# Corporate Report

**SUBJECT:** **Report on Comments – Draft Port Credit Local Area Plan And  
Built Form Guide - Ward 1**

**Response To Comments Table – Draft Port Credit Local Area Plan**

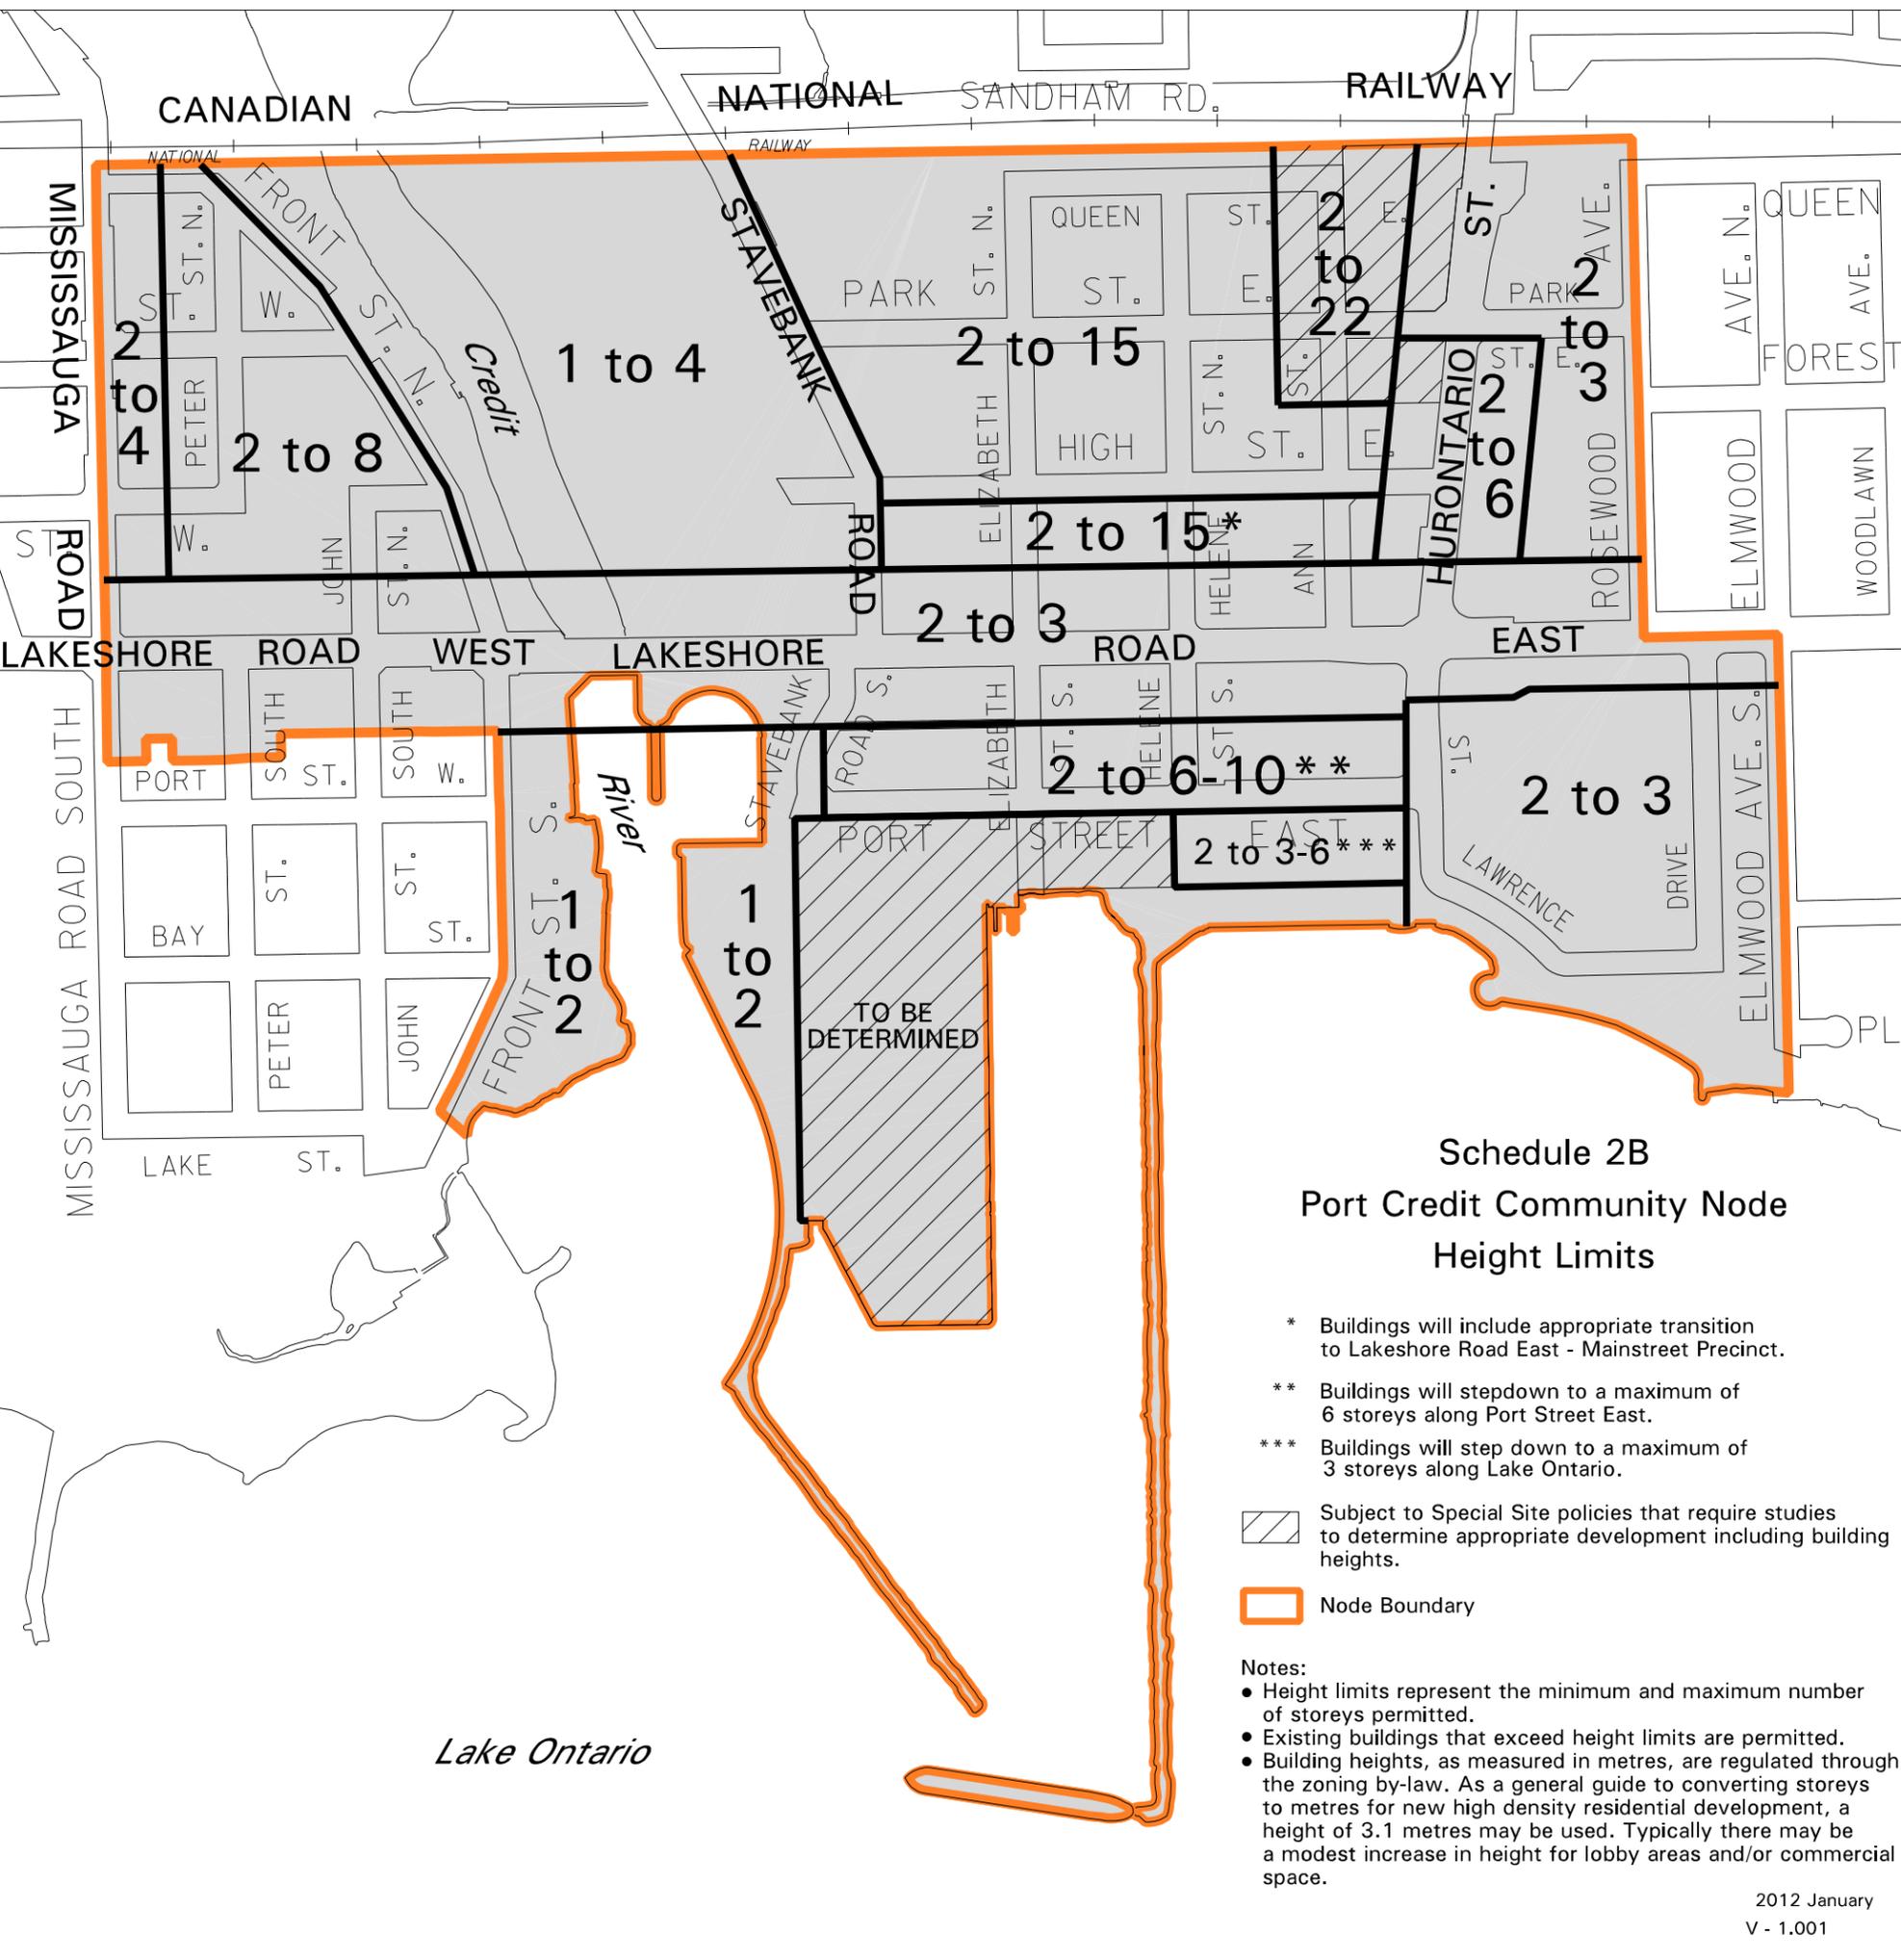
Location A:  
From: Residential Medium Density  
To: Mixed Use

Location B:  
From: To Be Determined  
To: Special Waterfront

Location F:  
From: Lake Ontario  
To: Greenbelt (with Ridgetown breakwater being added)

# Potential Opportunities for Road Network Improvements and Higher Order Transit

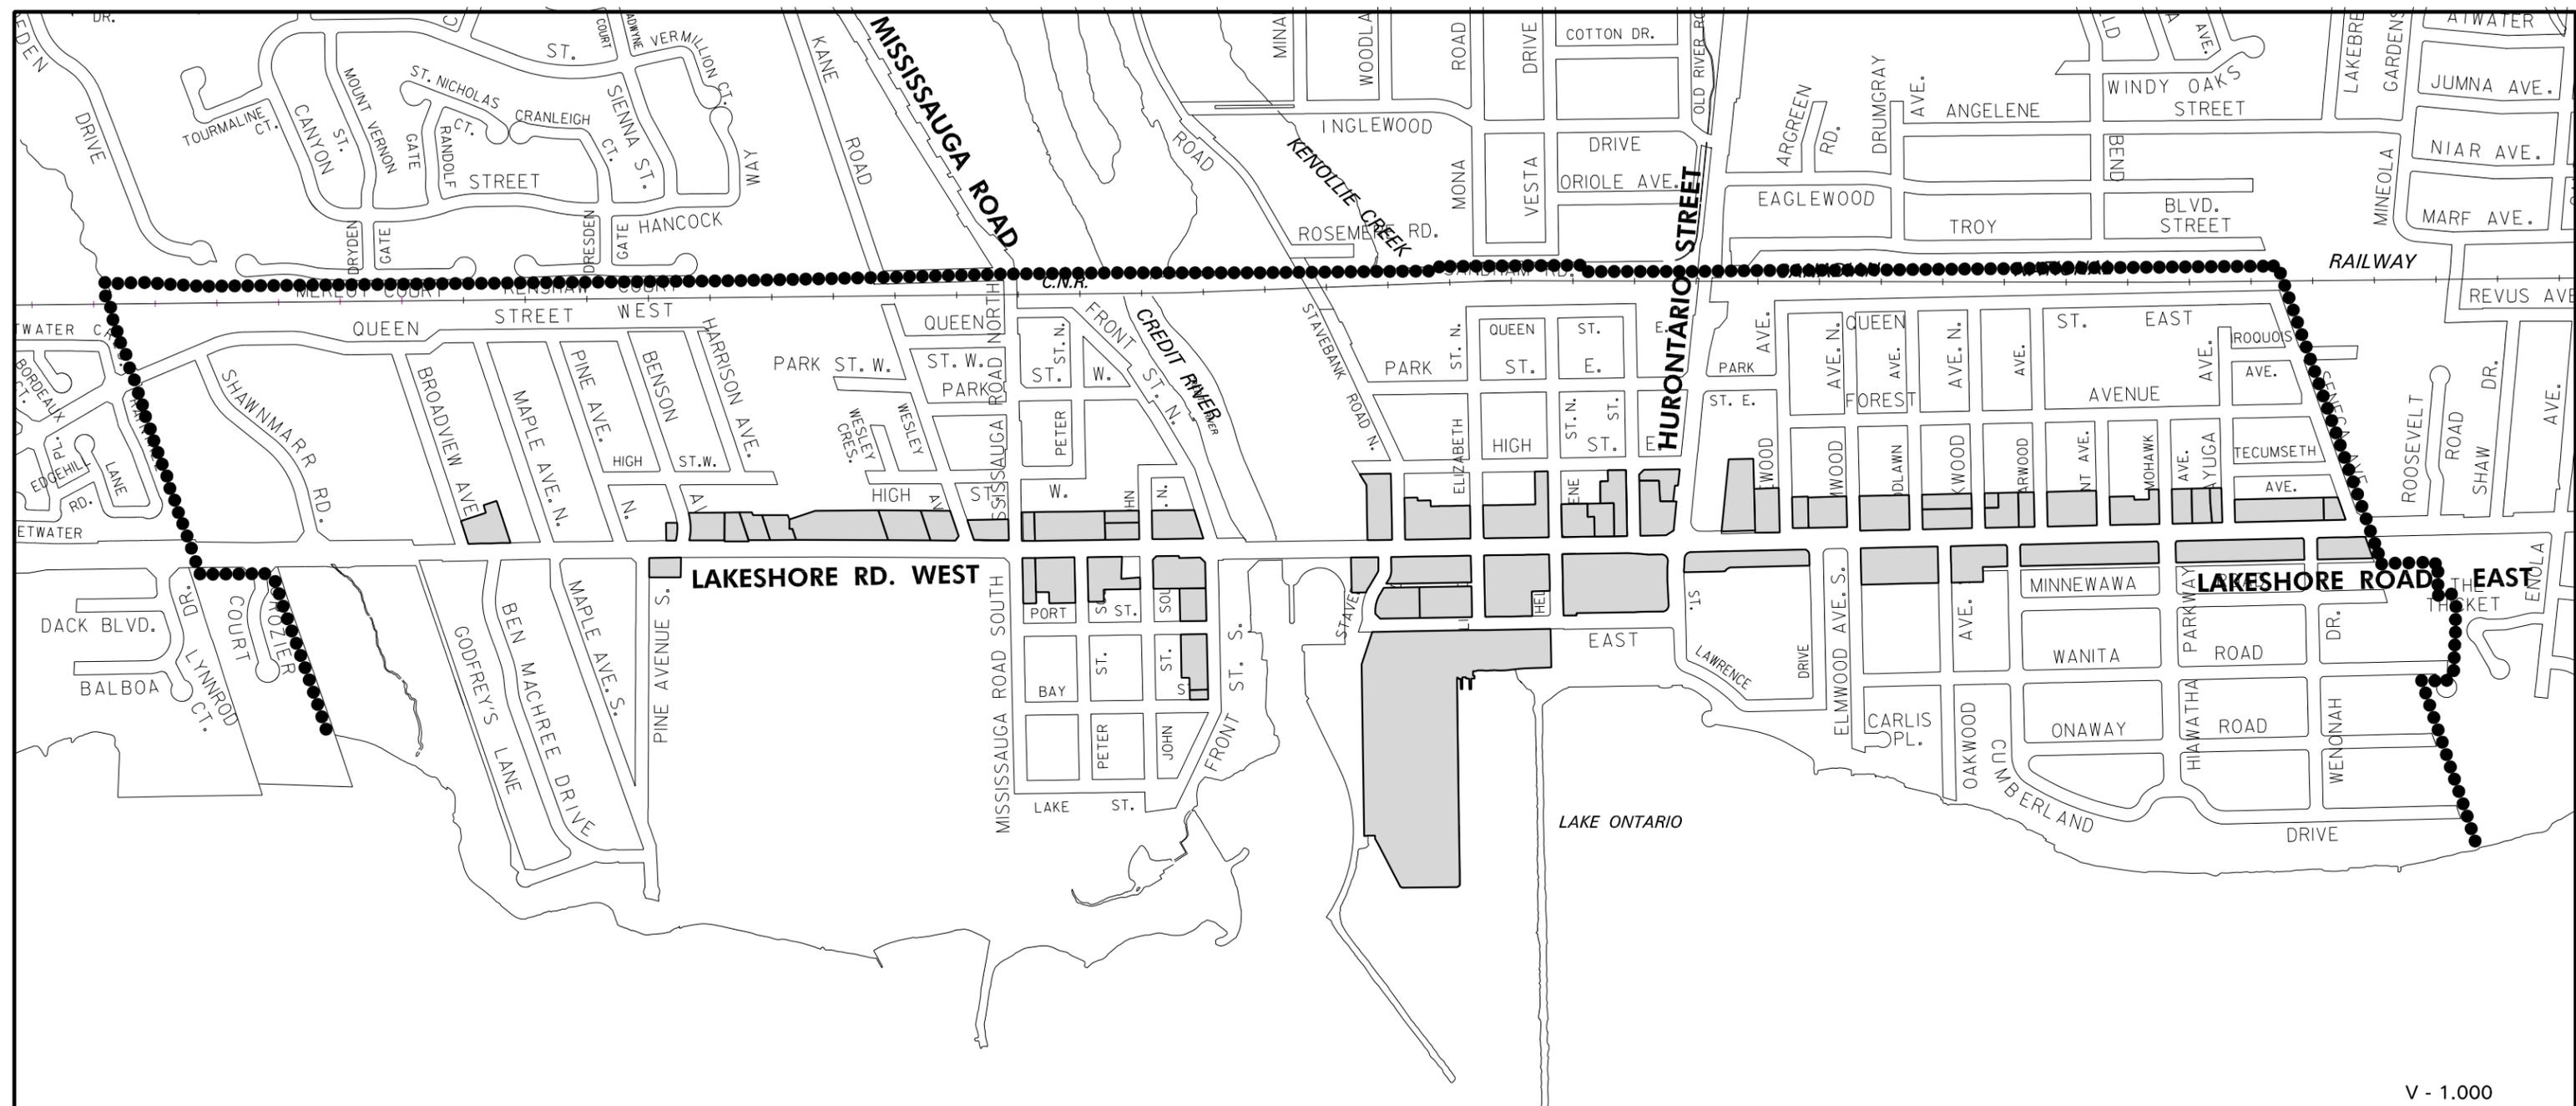
Transportation	9.1.13 Multi-Modal	Local Area Plan	Agreed.	26 That a new figure be added that

Respondent	Section	Issue	Comments	Recommendation To Draft Port Credit Local Area Plan
and Works	Network	should conceptually illustrate potential road and transit network improvements.		illustrates potential opportunities for road network improvements and higher order transit.
Transportation and Works	9.1.14 Multi-Modal Network	Local Area Plan should clarify that transportation and traffic studies are required for new development in Port Credit and that these studies have to identify strategies for limiting impacts.	Agreed.	27 That a new policy 9.1.14 be added to read:  <i><u>Development applications will be accompanied by transportation and traffic studies. Studies will address, amongst other matters, strategies for limiting impacts on the transportation network, where appropriate, including measures such as:</u></i>  <ul style="list-style-type: none"> <li>- <i><u>reduced parking standards;</u></i></li> <li>- <i><u>transportation demand management;</u></i></li> <li>- <i><u>transit-oriented design of the development;</u></i></li> <li>- <i><u>pedestrian/cycling connections; and</u></i></li> <li>- <i><u>access management plan.</u></i></li> </ul>
